**RE: Subsidence Management Plan Variation Application for Springvale Colliery
Longwalls 416 to 418: Variation to Longwall Cutting Height**

Attachment A: OEH review for Springvale Colliery Longwalls 411-418 Subsidence Management Plan Variation Application – Variation to Longwall Cutting Height
Attachment B: Report on field inspection of unnamed swamp (herein referred to as Little Sunnyside East Swamp)

OEH review**Springvale Colliery Longwalls 411-418****Subsidence Management Plan Variation Application****Variation to Longwall Cutting Height**

Figure 1. Mapped lineaments and Swamps above Springvale Mine

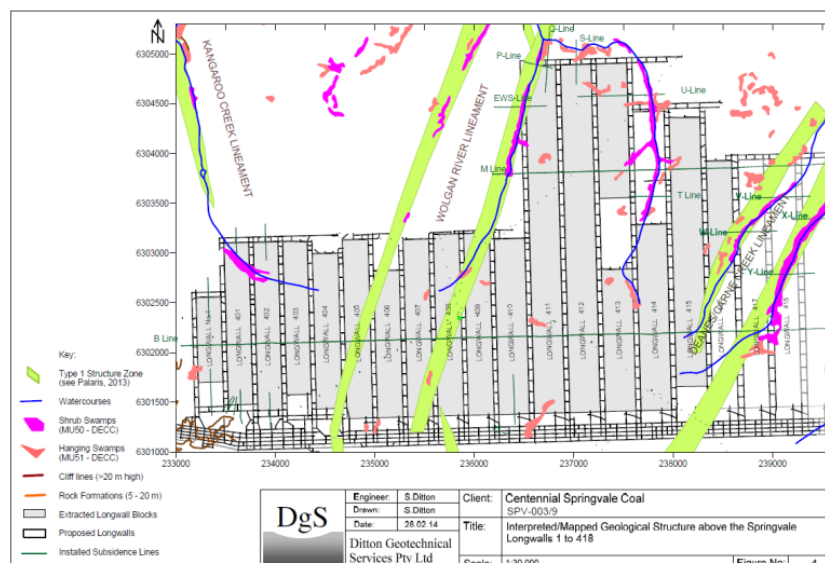
Three Type 1 structure zones are recognized in the Angus Place Colliery and Springvale Mine existing workings (Kangaroo Creek lineament, Wolgan River lineament and the Deanes Creek lineament). For the current set of longwalls these were mapped by DgS (2014) in relation to NPSS (Figure 1. - Figure 4 from DgS 2014).

Structure Type 1 Lineaments are located in the vicinity of the proposal. The Deanes Creek lineament extends directly below Carne West Swamp, running beneath Longwalls 415 to 418. Based on the draft EIS, mining of the lineament area would potentially result in subsidence of up to 1,450mm, significantly higher than the 1,000mm presented in the Variation application.

The subsidence assessment for the proposed increase in height for Longwalls 416 to 418 is based on the methodology of DgS (2014). Experience with this methodology in some other areas has identified that this approach can significantly underestimate actual subsidence. For example, OEH notes that subsidence using the same methodology for some longwalls at West Wallsend Colliery predictions underestimated subsidence by up to 30%. The DgS methodology used for this assessment is also based on a mean (and 95% confidence on the mean) and not a maximum. This means that maximum subsidence levels could well be much higher than even the predicted subsidence estimates provided. There are also no specific estimates for upsidence or valley closure provided for the mine plan, but OEH notes the important qualifier attached to DgS (2014) Table 1 that:

Since the estimated strains range from 3-7 mm/m compressive strain and 2-5 mm/m tensile strain, actual maximum strains could be as high as 14-28 mm/m compressive strain and 10-20mm tensile strain^a.

- 2.1 That the predicted subsidence for NPSS in the vicinity of Longwalls 411 to 418 be clarified, taking into account the influence of lineaments and the assessment of potential impacts reviewed in light of revised information if required.

Figure 2 Location of Unnamed Swamp

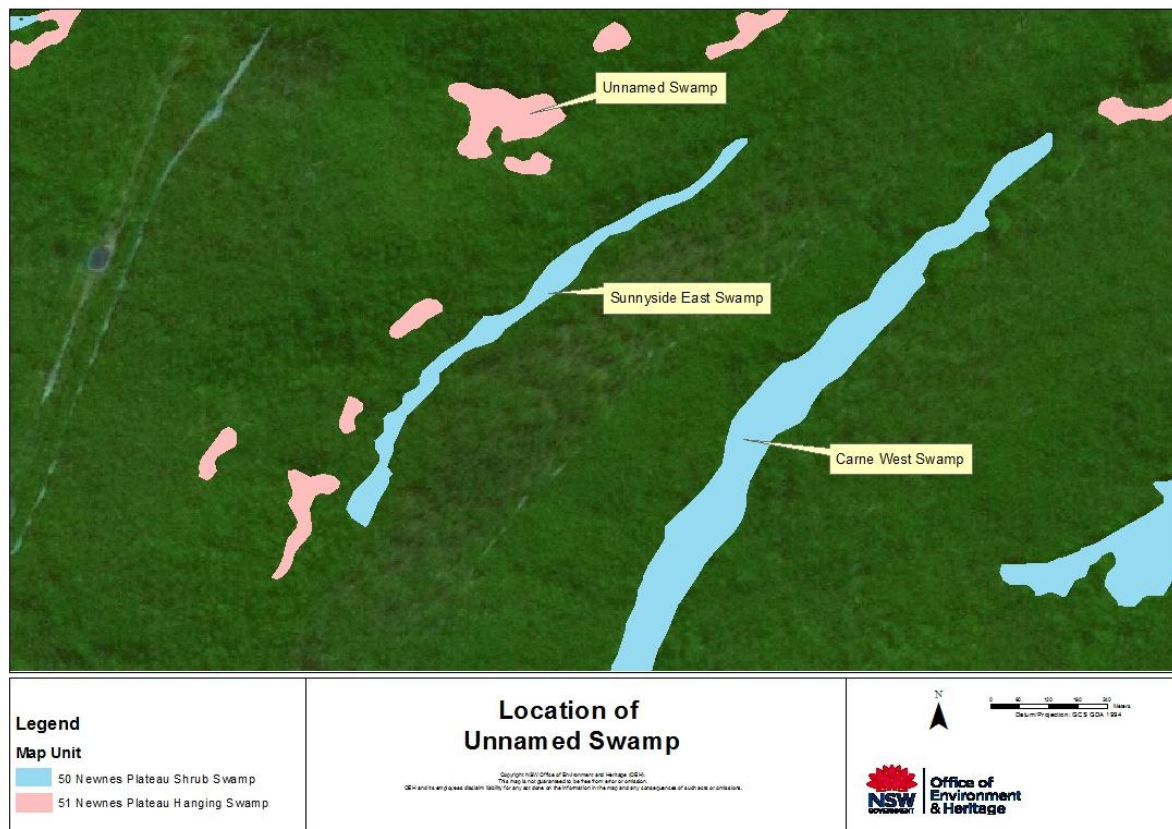
In addition, OEH advises that an unnamed swamp to the north of Sunnyside East Swamp, currently mapped as a Hanging Swamp, has been recently surveyed by Doug Benson of the Royal Botanic Garden and Domain Trust and found to meet the description of Newnes Plateau Shrub Swamp (Figure 2 and Attachment B). An area of 3.5m extraction height for Longwall 417 is located directly below this swamp.

- 3.1 Mining activities that could potentially result in impacts to NPSS should be avoided. A negligible impact criteria should be applied if mining is underneath or within the angle of draw of these swamps, particularly those listed above.
- 3.2 The swamp to the north of Sunnyside East Swamp, described in Attachment B, be recognised as NPSS rather than as a Hanging Swamp. The 3.5m cutting height should not be applied under this swamp.
